Title: Stage 1 Road Safety Audit

**Link Road to Clonlara Road, Baldonnell Business Park,
Dublin 22.**

Client: PUNCH Consulting Engineers

Report reference: 1462R01

Drawing 212126-PUN-XX-XX-M2-C-0420 P03

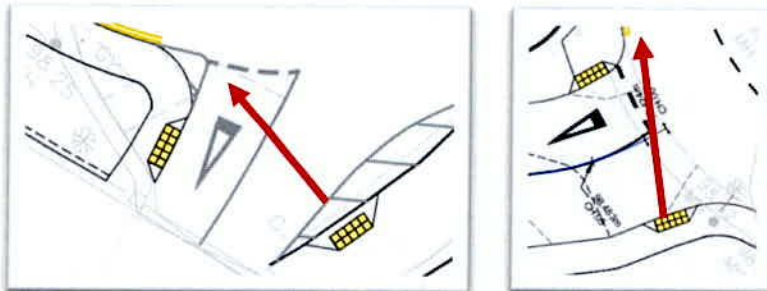
The tactile paving at the uncontrolled crossings do not align on either side of the carriageways. This could lead to blind or partially sighted pedestrians being directed incorrectly as they attempt to cross the carriageway. This could lead to collisions with passing vehicles.

It is recommended that the tactile paving be aligned.

Drawing 212126-PUN-XX-XX-M2-C-0420 P03

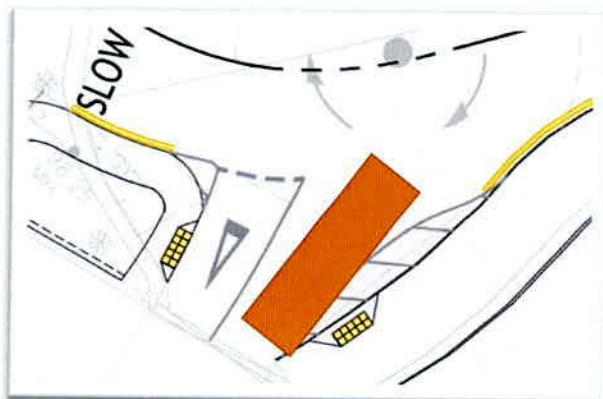
It is unclear if a HGV can park outside the Caulfield Transport gated entrance without overhanging the through road. If the trailer overhangs this could lead to side-swipe or rear-end collisions.

It is recommended that the gate be far enough back so that a HGV driver can pull clear of the carriageway when looking to speak through the intercom to gain access.
